# HISTORIC AND DESIGN REVIEW COMMISSION

**HDRC CASE NO:** 2022-100  
**ADDRESS:** 112 SOLEDAD ST  
**LEGAL DESCRIPTION:** NCB 106 BLK LOT 8A  
**ZONING:** D, H  
**CITY COUNCIL DIST.:** 1  
**DISTRICT:** Main/Military Plaza Historic District  
**LANDMARK:** Individual Landmark  
**APPLICANT:** Davis Sprinkle/sprinkle and co.  
**OWNER:** david weider/112 SOLEDAD PARTNERS LLC  
**TYPE OF WORK:** Amendment To Previous Application  
**APPLICATION RECEIVED:** February 03, 2022  
**60-DAY REVIEW:** Not applicable due to City Council Emergency Orders  
**CASE MANAGER:** Edward Hall

The applicant is requesting conceptual approval for the design of the rear river level wall and building façade at 112 Soledad.

EAST ELEVATION & SECTION - SAN ANTONIO RIVERWALK

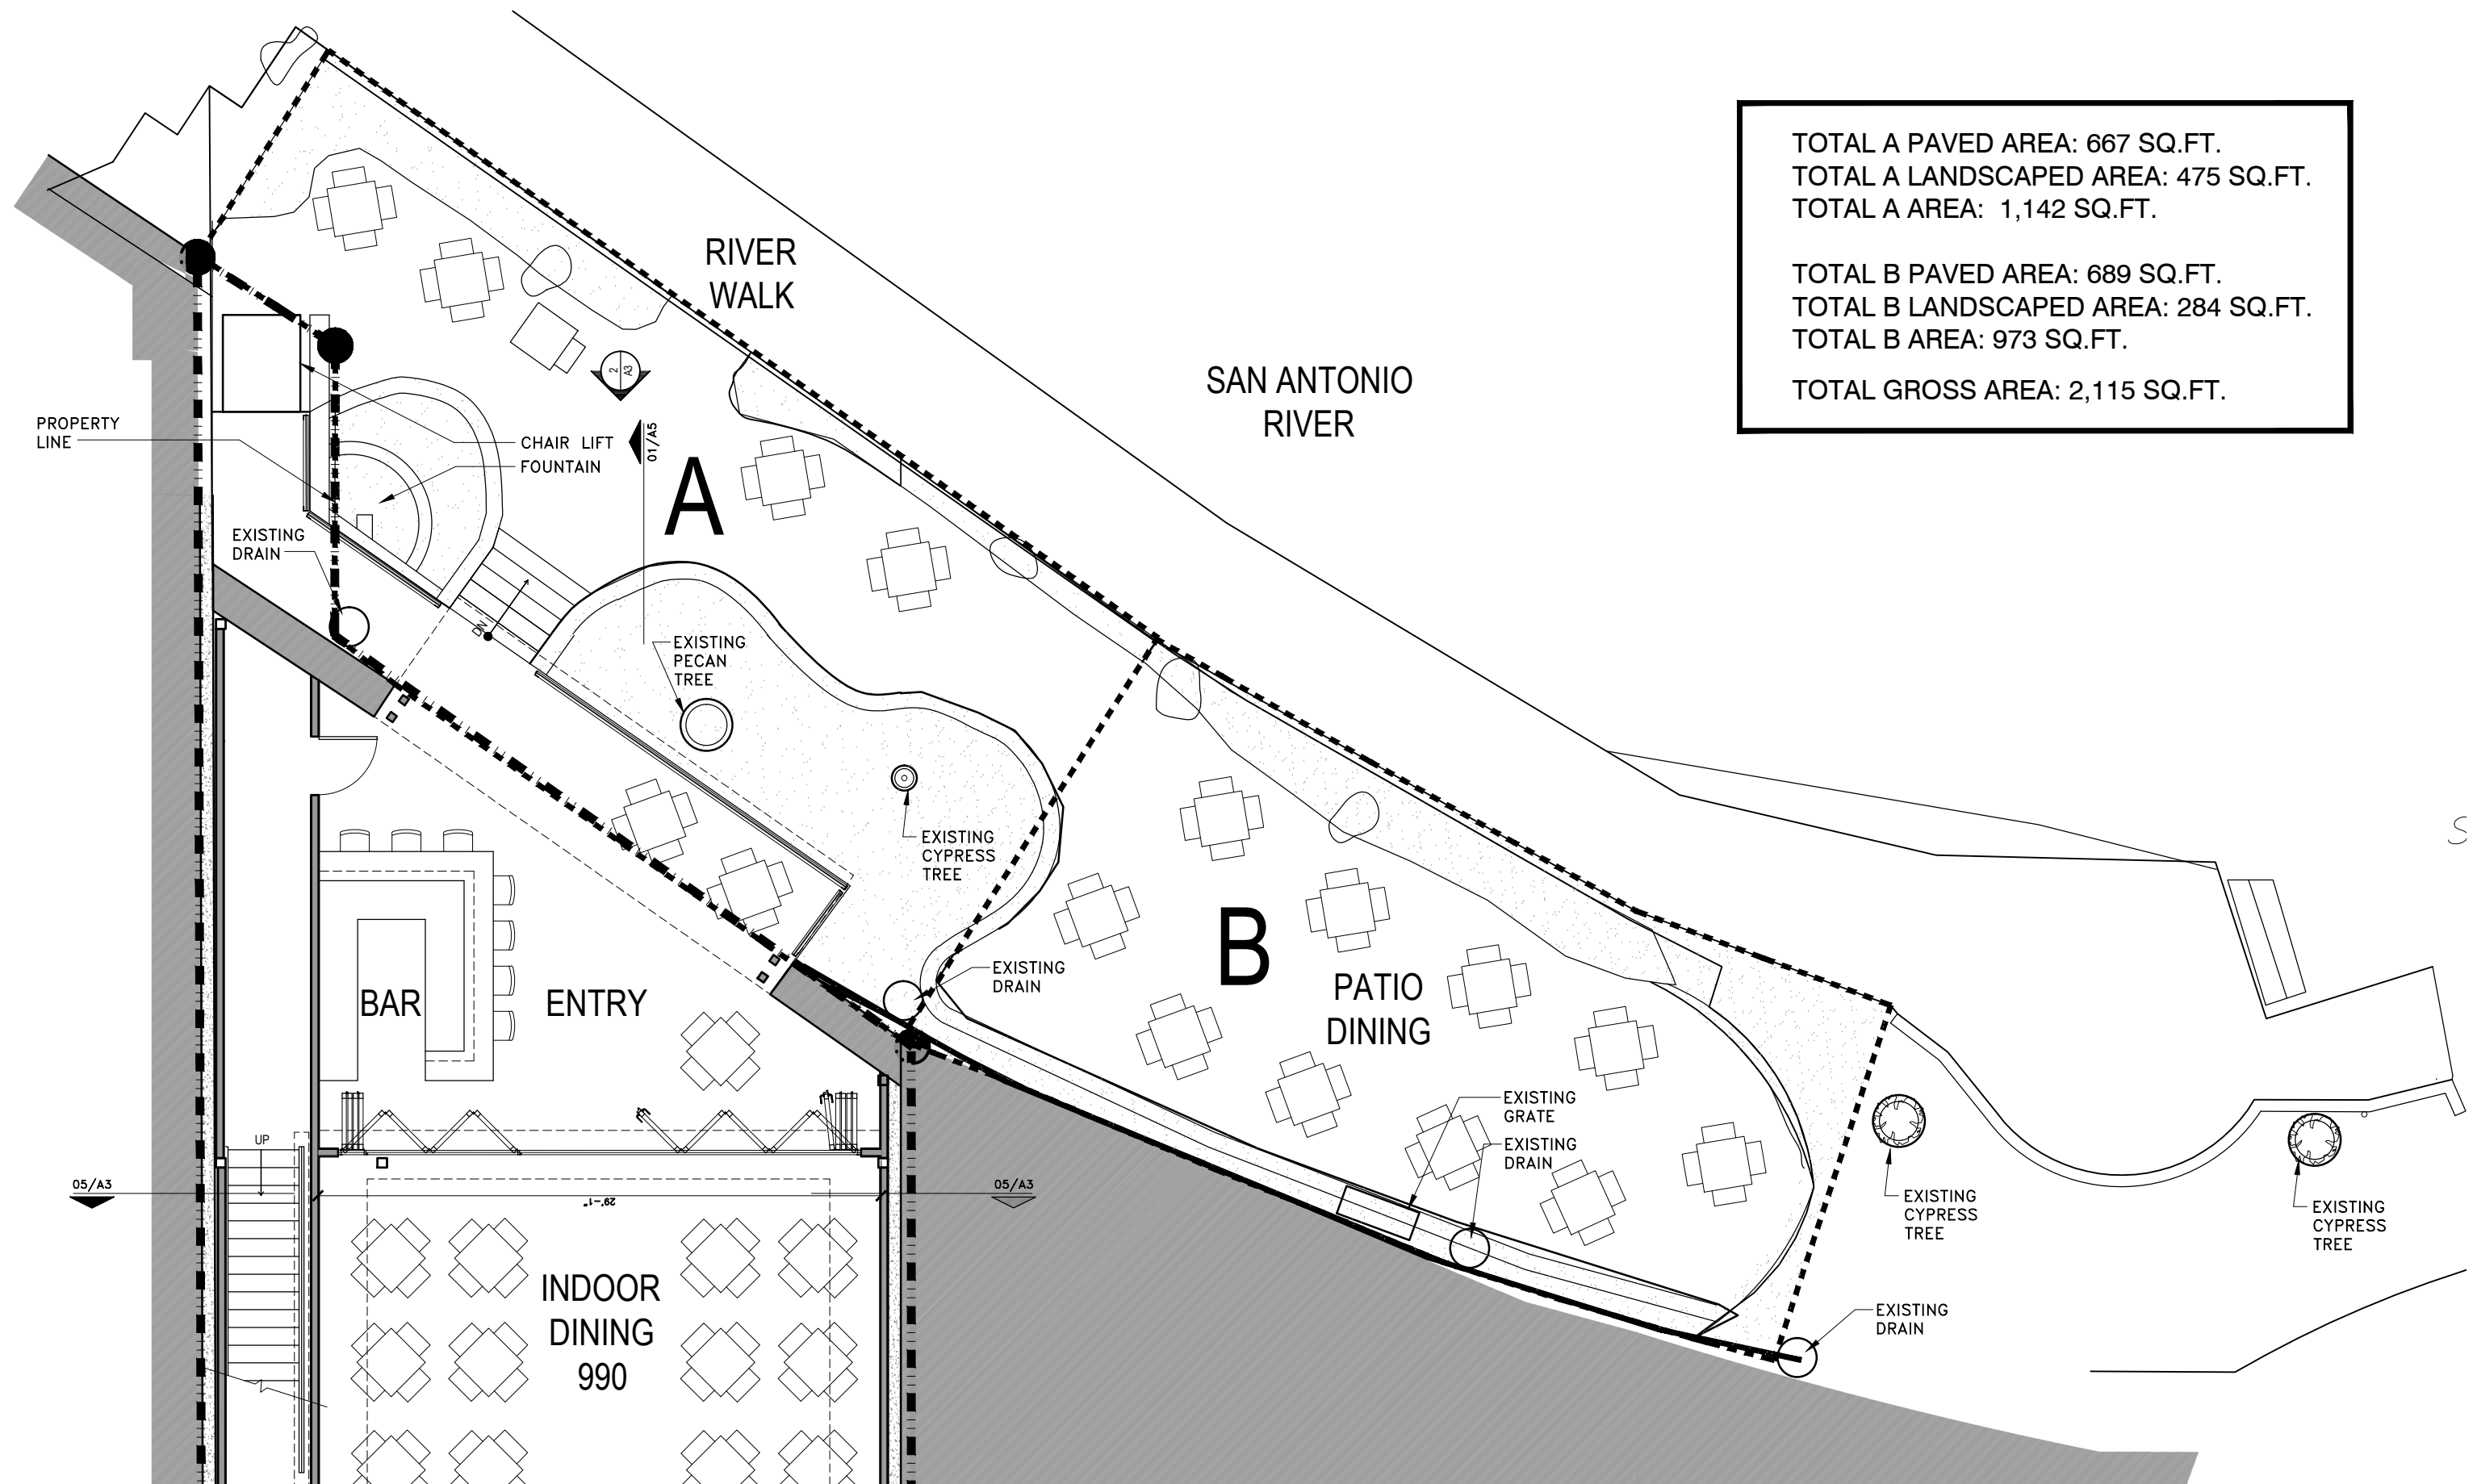
- e. **STONE WALL MODIFICATIONS** – Since conceptual approval in August 2021, the applicant has revised the design of the opening in the rear stone wall as well as the proposed rear elevation. Generally, staff finds the amendments to be appropriate. Staff finds that the applicant should provide documentation and a detailed plan for disassembly when returning to the Commission for final approval.

- f. **STONE WALL MODIFICATIONS** – When returning to the Commission for final approval, the applicant should have detailed construction documents of the rear stone wall, low stone walls and glass railing.

Staff recommends approval of the revised stone wall and rear façade based on findings a through h with the following stipulations:

- i. That the applicant provide documentation and a detailed plan for disassembly when returning to the Commission for final approval.
- ii. The applicant provide detailed construction documents of the rear stone wall, low stone walls and glass railing when returning to the Commission for final approval.
- iii. That coordination with Center City Development and Operations Department continue regarding all lease agreements and site modifications.
- iv. ARCHAEOLOGY – An archaeological investigation is required. The project shall comply with all federal, state, and local laws, rules, and regulations regarding archaeology, as applicable.
